#### Re: Marist Catholic College North Shore (SSDA-10473)

We refer to DPIE letter dated 20.12.2021 Response to Submissions and SDRP Third Review in response to State Significant Development Application for Marist Catholic College North Shore and specifically comments raised in relation to the Architectural design.

# Marist Catholic College North Shore Masterplan

Response to Submissions

# 2.0 ARCHITECTURAL RESPONSE PREVIOUS SCHEME COMPARISON

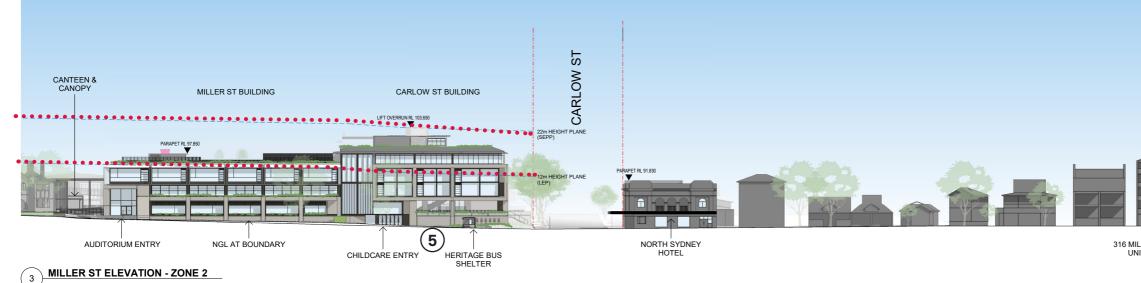
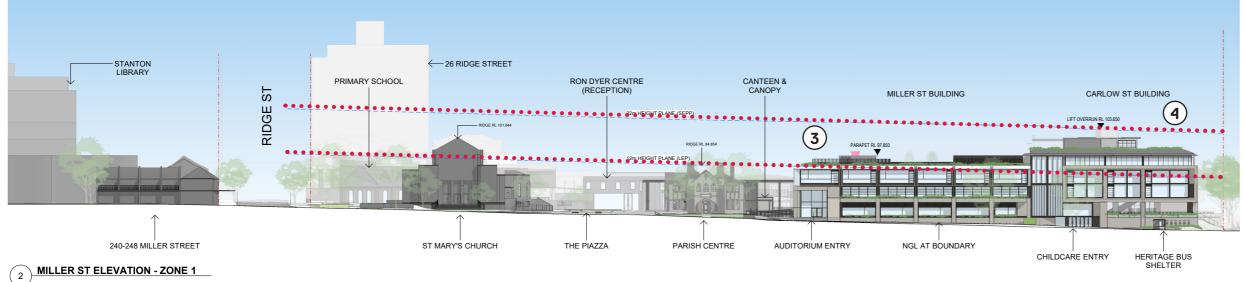
MATTER RAISED	COMMENT
Heritage	
The bulk and scale of the building at the corner of Miller and Carlow Street has not been assessed. The Department has raised this concern earlier and considers that the scale of the proposal at this corner should be reduced. The design should	Refer to Architectural design statement Section 2.0 Architectural response, drawing DA-200 Streetscape Elevations, DA-210 Building Elevations The scale of the building has been reduced by revisiting the design of top floor of the

be revisited with the goal of being able to provide a proposed corner building of a form, that more sympathetically responds to the heritage aspects of the surrounding context. Miller Carlow building. The lightweight metal portal framing around the upper windows has been removed and the glazing line setback from the facade. This has reduced the visual bulk of the top floor. This also emphasises the double storey window frame elements in the brick facade similar to the language of the adjacent North Sydney Hotel. Additional curved brickwork detailing has been added to soften the facade. The main bulk of the facade is maintained within the LEP height plane and is sympathetic to the surrounding context.

- 1. Removed lightweight metal framing on top level, simplified the glazing and recessed to reduce the visual bulk of top floor.
- 2. Added curved corner brick detailing to soften brick base
- 3. Recessed extent of roof recreation to reduce presence along street
- 4. Refined window fenestration details for further articulation on facade

#### **RTS - ARCHITECTURAL CONSIDERATIONS**

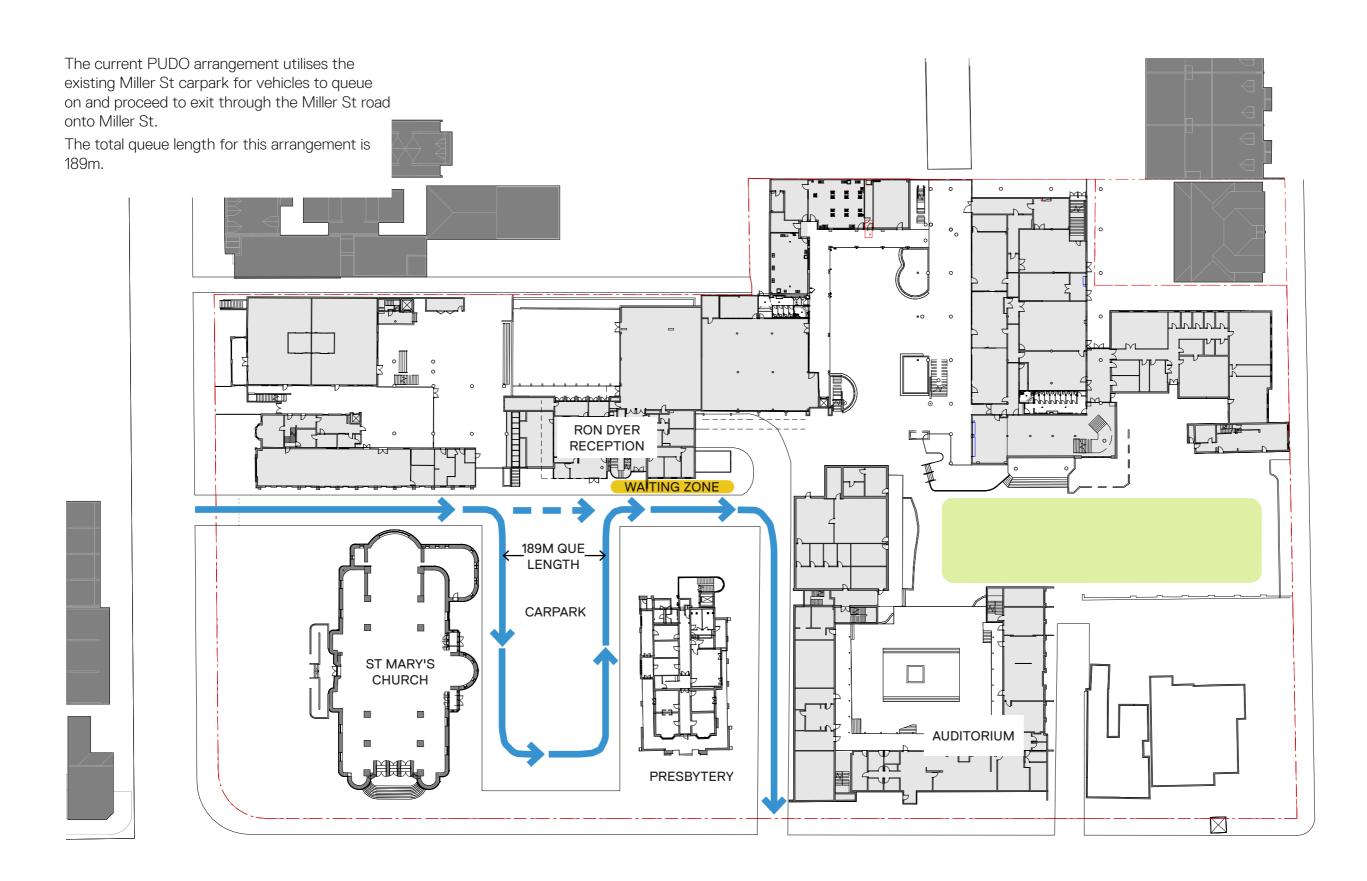
01	4-storey height of Carlow St, elevation not fitting with streetscape and character	Refer to Section 2.0 Architectural response, and drawing DA-200 Streetscape Elevations These describe the considered massing and articulation strategy that responds sensitively to the neighbouring conditions. CGI imagery show how the building sits in relation to the streetscape. As shown in the CGIs, existing street trees provide a natural screening to both Miller St and Carlow St elevation. Landscaping treatment is provided along both Miller St and Carlow Street, with additional planting and trees provided at the corner to soften the edge and reduce the bulk of the brick base.
NOI	SE AND PRIVACY	
01	Lack of consideration to protect the surrounding residence The western elevation is likely to result in overlooking into private residences	Refer to Section 2.0 Architectural response This describes the building articulation and screening. The Carlow Building has a public face to Carlow street however is inward looking to provide protection and privacy for the School. The considered massing and articulation strategy that responds sensitively to the neighbouring conditions. Window fenestrations are recessed to provide articulation as well as privacy and screened views from the site.

OTH	IER	
01	Lack of consideration to increased pedestrian use of Carlow Street and Miller Street, thus requiring wider footpaths	Refer to drawing DA-101 GA Plan - Basement Zone 2 The proposal has taken into consideration North Sydney Council footpath and public domain guidelines. The landscaping and planter design to the street boundary has been changed to increase the width of pedestrian pathway, especially behind the Heritage bus shelter which occupies the majority of the Miller Street footpath at this point. The proposed landscape treatment within the setback zone to the buildings facade along both Miller and Carlow Street provide significant contribution to the streetscape and public domain in comparison to the existing timber boundary fence.

### TRAFFIC FLOWS THROUGH SITE PROPOSED K - YR1 PICK-UP / DROP OFF

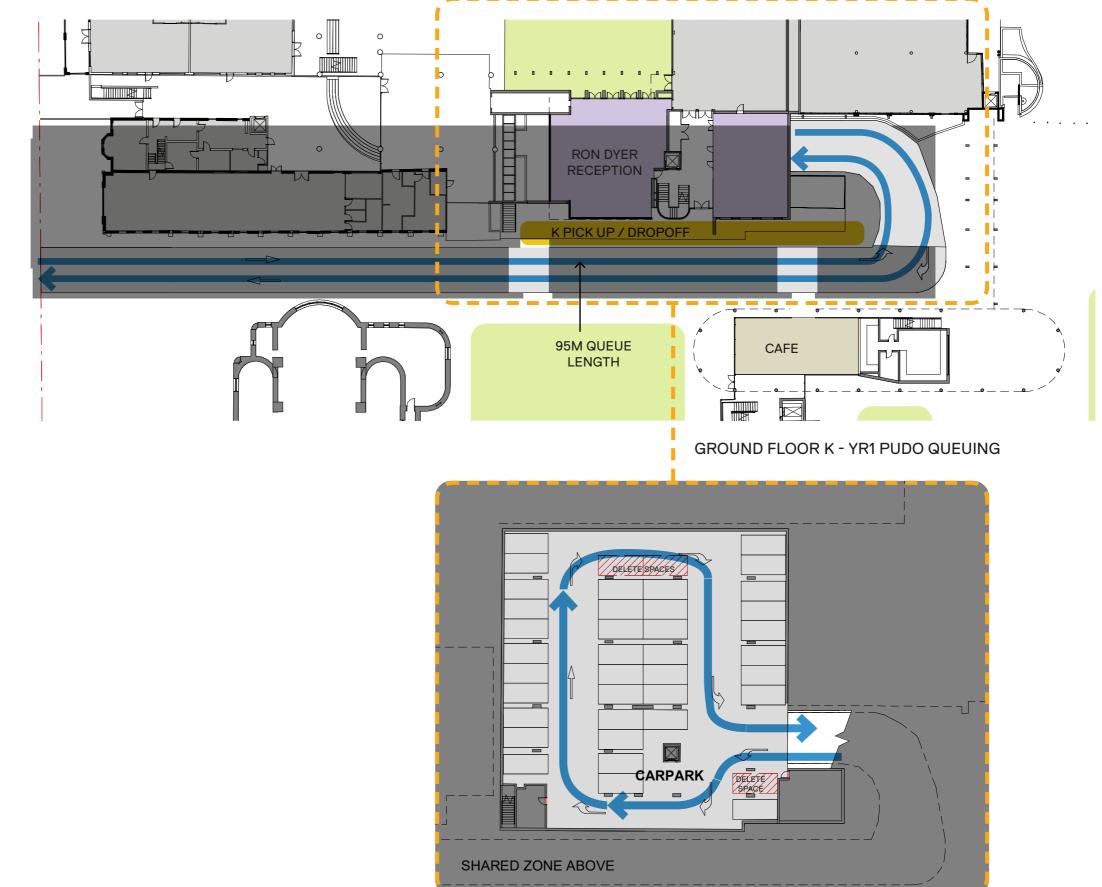
Clarification of the design and use of the pick-up/drop-off (PUDO) zone for kindergarten to year 1 students on the north-south access, including: updated architectural / landscape plans to show the surface PUDO zone. confirmation of the number of PUDO spaces and vehicle queuing capacity as well as the ability of vehicles to pass in the event the PUDO spaces are occupied.	Refer to Architectural design statement Section 5.0 APPENDIX F - Student Drop off/Pick up for existing and proposed Drop off/Pick up zones for kindergarten and year 1 students. Architectural and Landscape drawings show the North/South access and PUDO zone arrangement. Refer to traffic engineering report for further information.
Clarification of the adequacy of PUDO facilities including: whether the existing PUDO facility is capable of accommodating existing peak demand, whether it results in queuing onto Ridge Street and if so the extent of queuing. an assessment of the proposed PUDO spaces (12 spaces for Years 2-12, three spaces for Kinder to Year 1 and nine spaces for childcare) to demonstrate that this is sufficient to meet demand during peak periods. confirm the predicted maximum vehicle queue length for each proposed PUDO during peak periods. confirm whether the PUDO times for Years 2-12 and the childcare overlap, and whether this cumulative demand results in any adverse queuing.	Refer to Architectural design statement Section 5.0 APPENDIX F - Student Drop off/Pick up for proposed Drop off/Pick up zone for year 2-12 students. Refer to traffic engineering report for further information.

The proposed PUDO arrangement goes through the Ridge St shared road where there is a PUDO aisle for K-1 students. Vehicles then travel down into the Ron Dyer Centre basement, where they can loop and exit via the shared road.

This PUDO is reserved for years K-1 students. The 95m queue length accommodates approximately 15 cars, with an additional
